No.: 07 TS - 04
January 22, 2007

SUBJECT: **MBE 4000 Cylinder Head And Head Gasket Information**

Figure 1 Cylinder Head and Head Gasket

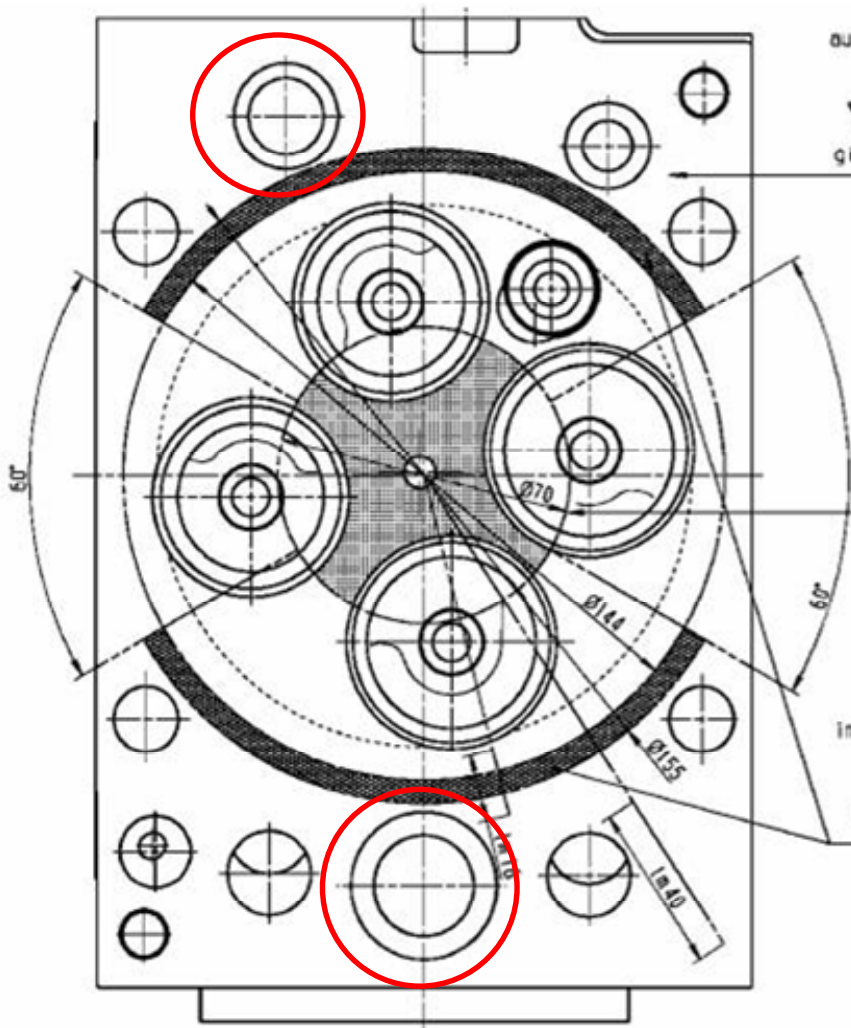
A new cylinder head and head gasket has been introduced. A 0.3mm recess was machined around each coolant inlet and outlet port in the cylinder head to give a better mating surface for the thicker rubber seal in the new head gasket. See the red circled areas below. The new cylinder head and gasket became effective with engine S/N: 0460866443 built on August 1, 2006.

- The new cylinder head and gasket *MUST* be used together. Do *NOT* use a new head with older style gaskets, or a new gasket with an older style head.
- The former heads have been superseded to the new style.
- The former head gasket (P/N: 4570161120) will remain as a serviceable part.
